TECHNICAL SERVICE BULLETIN

Difficulty Unlatching Or Latching And/Or Locking Or Unlocking Doors - Built On Or Before 7-Jun-2020

20-2421
10 December 2020

Ford 2018-2019 Expedition
Lincoln 2018-2019 Navigator

Figure 1

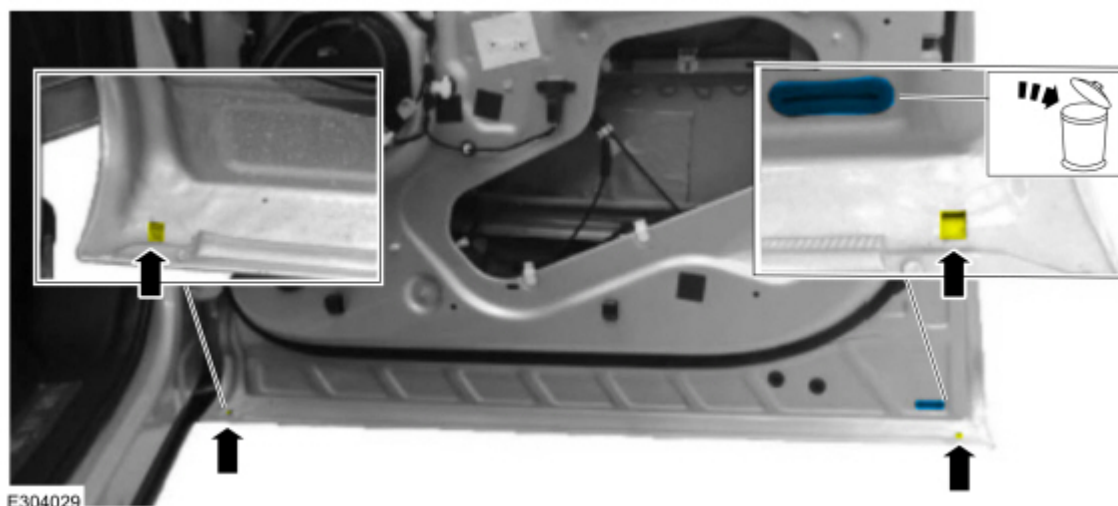
3. For all affected doors, remove and discard the rubber drain plug using a plastic trim tool. Using compressed air, clean obstructions, debris, foreign material and residual water from all door drain holes. (Figure 1)
